UNITED STATES PATENT AND TRADEMARK OFFICE

APPLICATION NO.	FILING DATE	FIRST NAMED INVENTOR	ATTORNEY DOCKET NO.	CONFIRMATION NO.
10/524,878	02/17/2005	Kurt Johannes Weschenfelder	W1.1882 PCT-US	5620

Office Action Summary	Application No.		Applicant(s)	
	10/524,878		WESCHENFELDER ET AL.	
	Examiner		Art Unit	
	Leslie J. Evanisko		2854

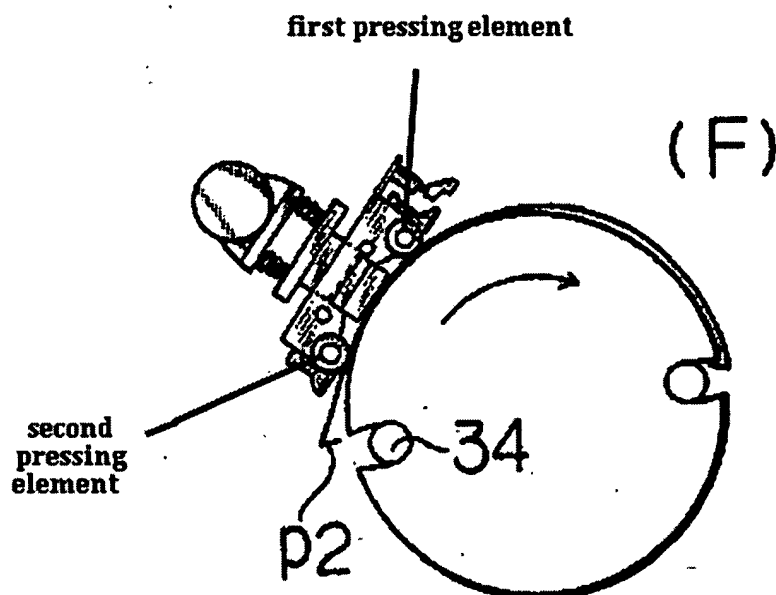
9. Claims 70-72 are rejected under 35 U.S.C. 102(b) as being anticipated by Suzuki et al. (US 4,727,807). Suzuki et al. teach a method for pressing a dressing P on a cylinder A of a printing press comprising: providing at least one first pressing element positioned adjacent a surface of the cylinder, providing at least one second pressing element positioned adjacent the surface of the cylinder, spacing the first and second pressing elements apart from each other in a circumferential direction of the cylinder with the first pressing element leading and the second pressing element trailing in a production direction of rotation of the cylinder, providing suspension legs P1, P2 beveled off at ends of the dressing, providing at least one axially extending, dressing suspension leg receiving opening a1 in the surface of the cylinder, inserting a leading one of the dressing suspension legs into the opening (Fig. 8(D)), rotating the cylinder in the production direction (Figs 8(E), 8(F)), and using the second pressing element for pressing a trailing one of the dressing suspension legs into the opening (Fig. 8(G)). Particular attention is invited to Figures 8(A)-8(G) of Suzuki et al. and specifically, the marked up copy of Figure 8(F) shown below.
